CONNECTING OF DANFOSS MOTORS
WITH BUILT IN FREQUENCY INVERTER

FAN REPLACEMENT FCM300->FCM106
19432-0002 (INK-FL-0103EN)

SINGLE FAN

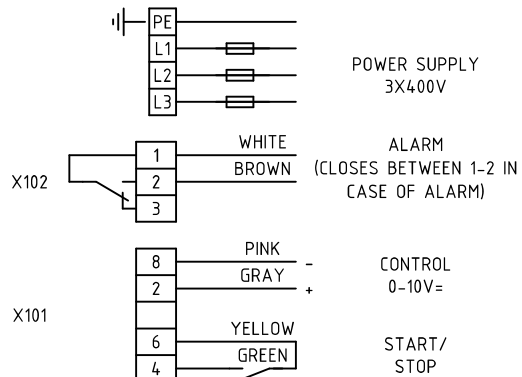
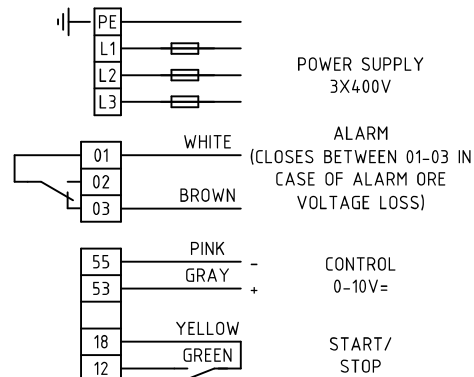
IN CASE OF EXTERNAL ALARM RELAY (GENERATION 1)

DOUBLE FAN

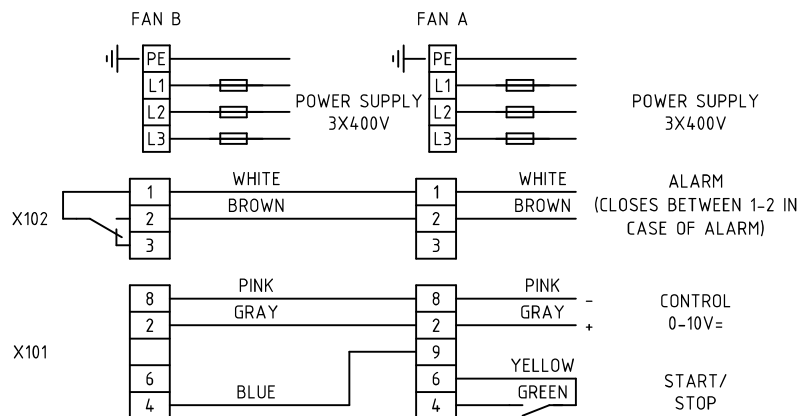
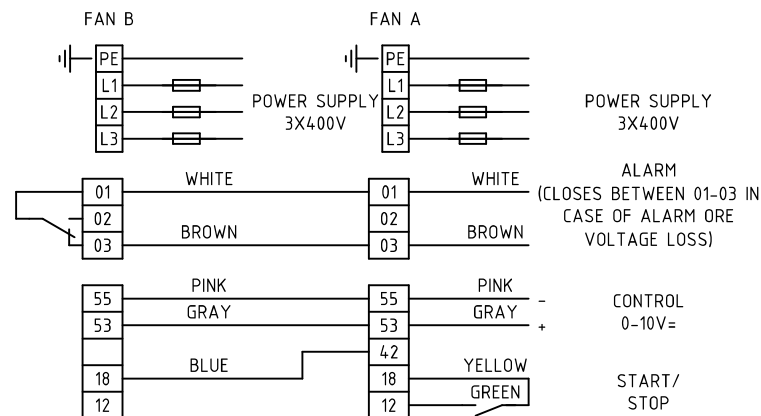
IT IS POSSIBLE TO REPLACE ONE OF THE MOTORS IN A DOUBLE FAN SET UP, TO USE 1PSC FCM300 AND 1PSC FCM106 TOGETHER
